PEV Low temperature procedure update

Proposal EC-JRC

WLTP Subgroup EV
Web-meeting, February 5th, 2020

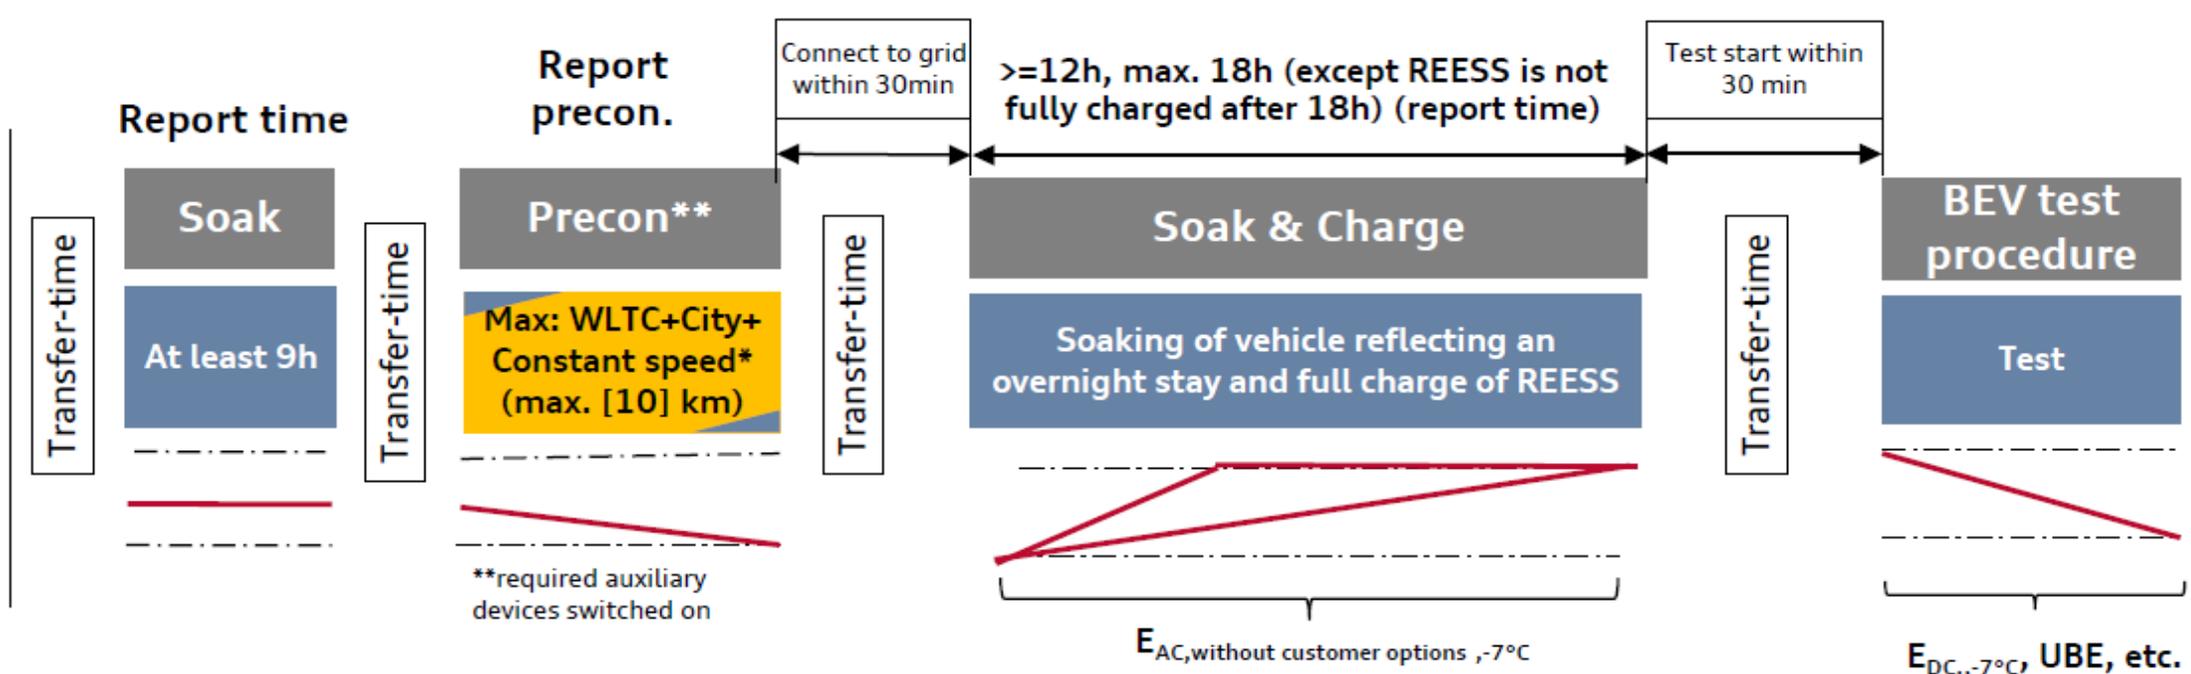
EC-JRC comments

Vehicle transfer to the soak area within [10] minutes

Soak @ -7C for at least 9h

[Initial SoC of the REESS to be defined]

The REESS shall not be charged during the soak period

Vehicle transfer from the soak area This shall be done without any unjustified delay and in any case within [10] minutes

Preconditioning @ -7C

Constant speed during preconditioning needs to be linked to constant speed in test procedure

Break-off-criterion as defined for type 1 test for PEV (3.4.4.2.3. of Annex 8)

Connection to grid shall be done without any unjustified delay, and in any case within [30] minutes. During that time the vehicle shall not receive unjustified exposure to temperatures higher than -7 °C but if that is unavoidable this time should in any case be limited to a maximum of [10] minutes.

Soak and charge @ -7C

The REESS shall be charged with the same charge power as for the Type 1 test, unless it can be justified that there are physical limitations that need to be observed.

Report time and E_{AC}

Vehicle transfer shall be done without any unjustified delay and in any case within [10] minutes. During that time the vehicle shall not receive unjustified exposure to temperatures higher than -7 °C but if that is unavoidable this time should in any case be limited to a maximum of [10] minutes

Test procedure @ -7C

CCT or STP @-7C according to the proposed flow chart in slide 5 of 191211_draft_update_proposal_Low-Temperature-Test_ACEA_with_comments_SG_EV.pdf (see next slide)

To be defined initial SoC of REESS

The initial SoC shall be set to a level which allows to drive maximum WLTC+City+ constant speed* (max. [10] km)

[Initial SoC setting @ 23C]
